Atashi Fashion Ltd. (New)

Plot No.- 83/2, Joypura, Dhamrai
(23.913781, 90.176976)

10th June 2018

Section size not mentioned in drawing

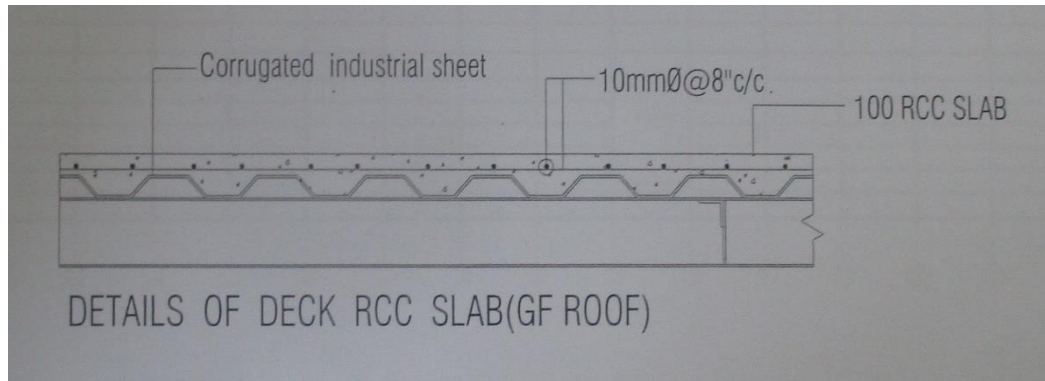
Sectional size of column, beam and rafters were not shown in drawings.

100 mm RCC slab shown in drawing but 175mm thick slab observed on site.

There are some discrepancies in provided drawings of Main building. Factory is required to update the as-built drawings for the structure.

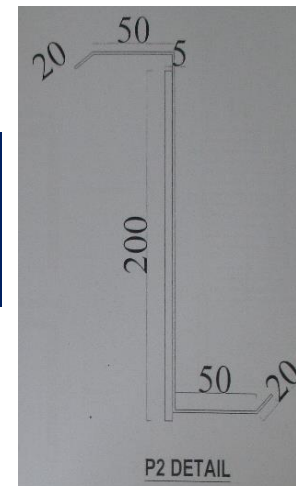
Thickness of purlin was shown 5mm where 3 mm observed on site. Also, flange was observed 75 mm instead of 50mm.

Implement the floor load management program

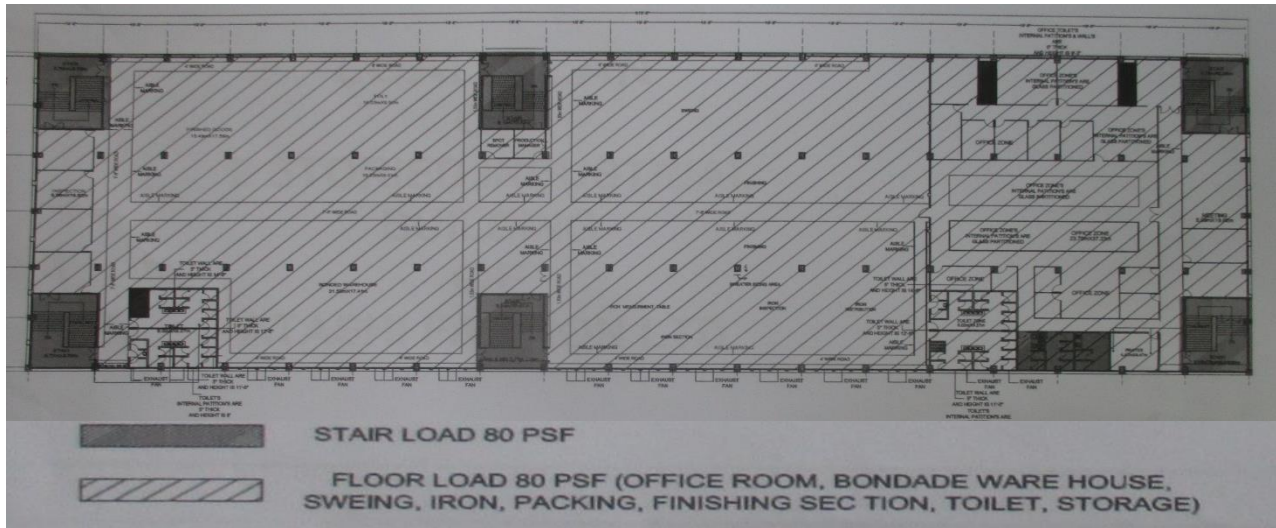
No visible load plan observed to maintain the design live load.
